P&Z CASE # SP2021-017 P&Z DATE 07/13/21 CC DATE _____ APPROVED/DENIE _____

SITE PLAN
 LOT 1, BLOCK A, CREEKSIDE COMMONS ADDITION
 NWC STATE HIGHWAY 205 & F.M. 549
 A 1.50 ACRE TRACT OF LAND IN THE
 WILLIAM W. FORD SURVEY, ABST. NO 80
 CITY OF ROCKWALL, ROCKWALL COUNTY, TEXAS
 CITY PROJECT #00000
 June 10, 2021

LANDSCAPE PLANTING PLAN
 7-ELEVEN STORE
 NWC STATE HIGHWAY 205 & FM 549
 ROCKWALL, TEXAS

- ARCHITECTURAL DESIGN ELEMENTS
- CANOPIES
 - TOWER ELEMENTS
 - TEXTURED SURFACES
 - VARIED ROOF LINES
 - RECESSES/PROJECTIONS
 - CORNICE
 - COVERED WINDOWS

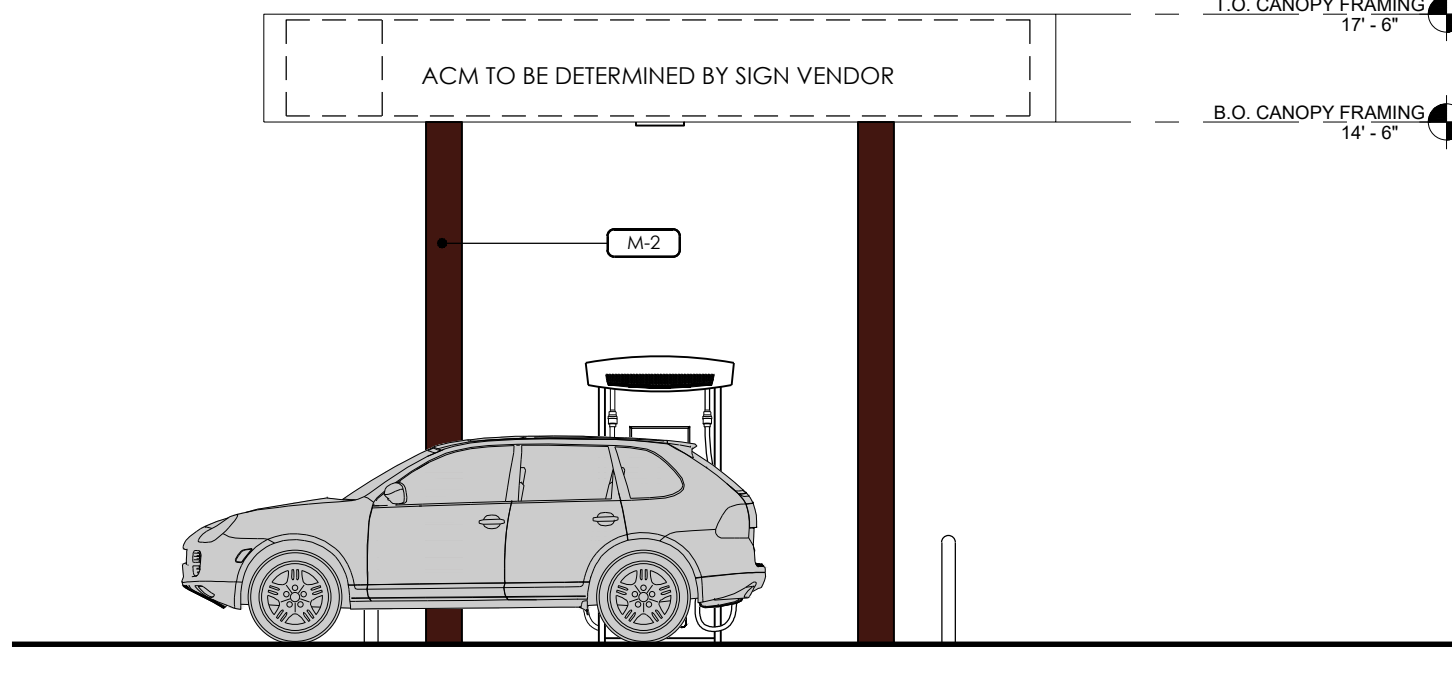
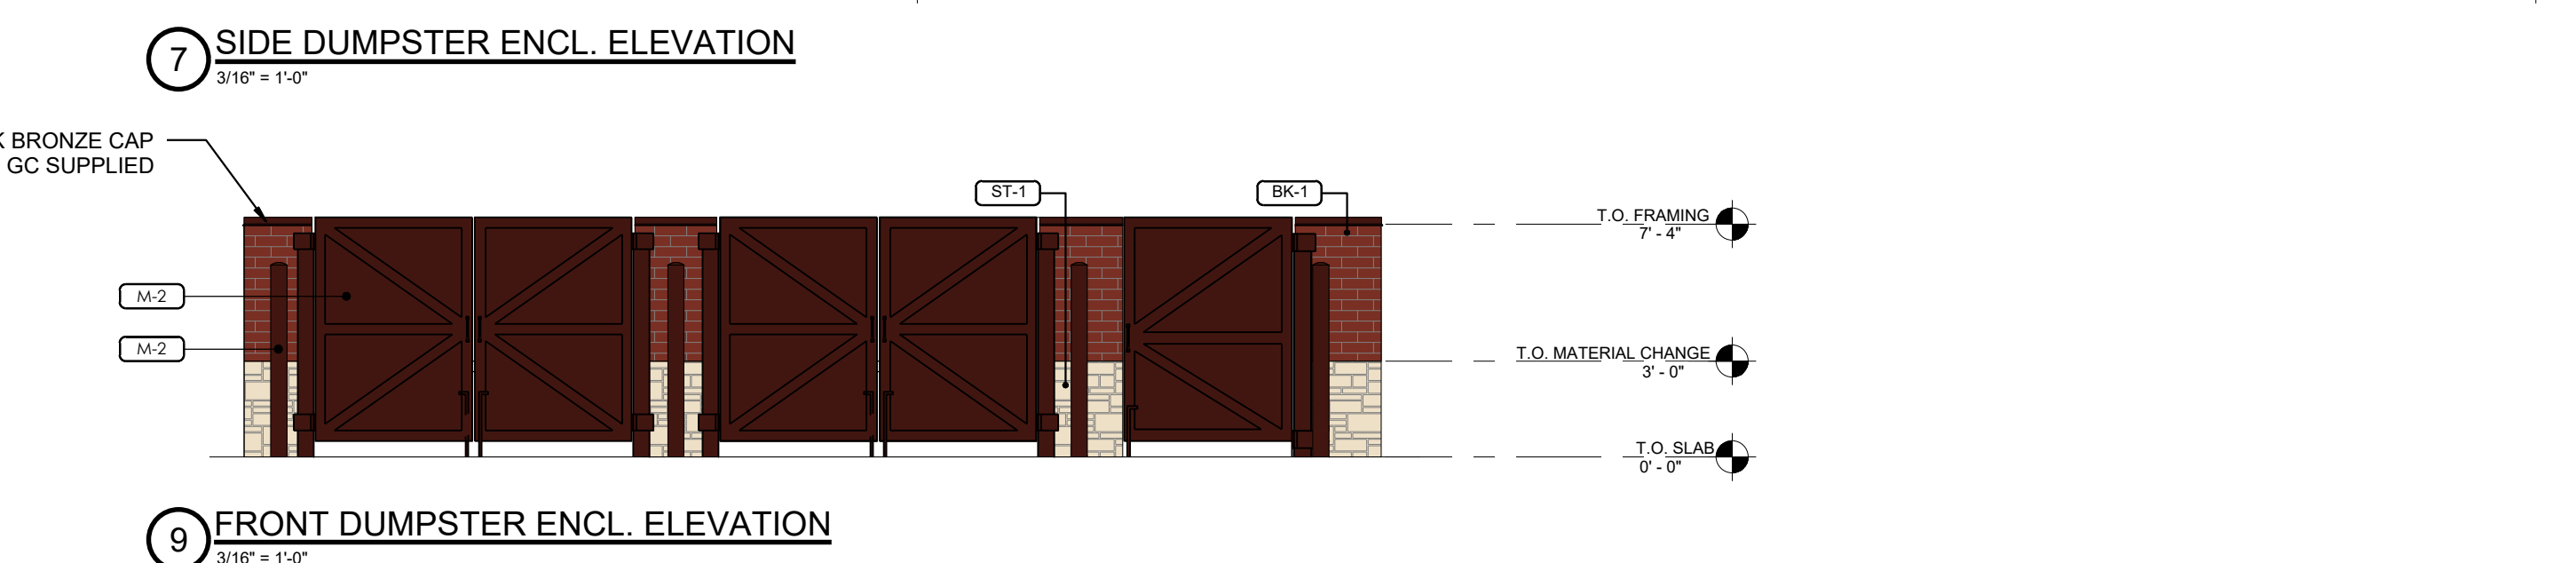
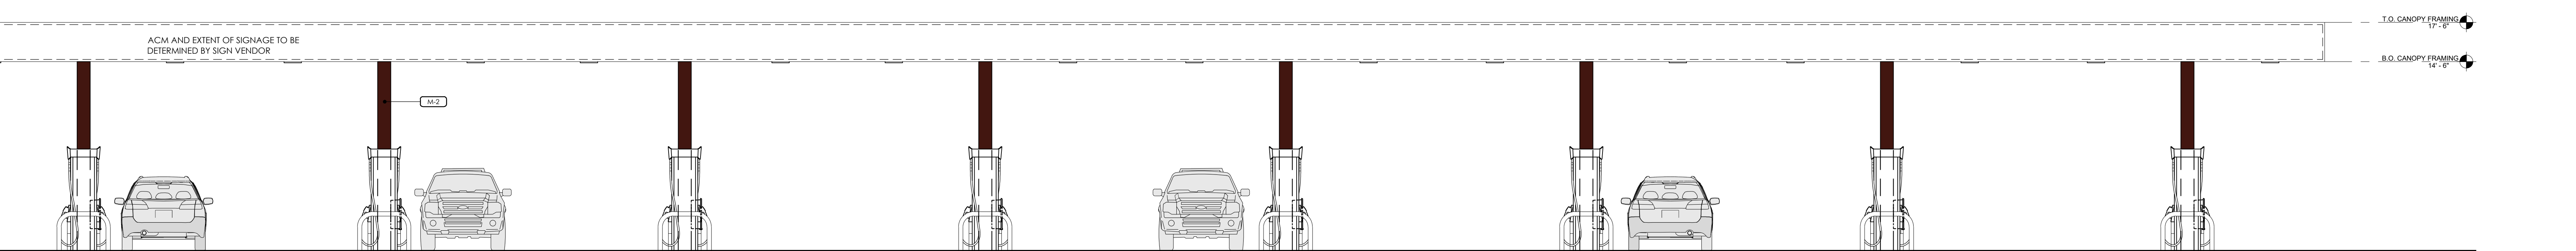
1) Building Articulation – As depicted, the building elevations do not meet the articulation standards as required in Figure 7 of Subsection 04.01.C, of Article 05, of the UDC for the following: (§04.01.C, Art. 05,UDC)
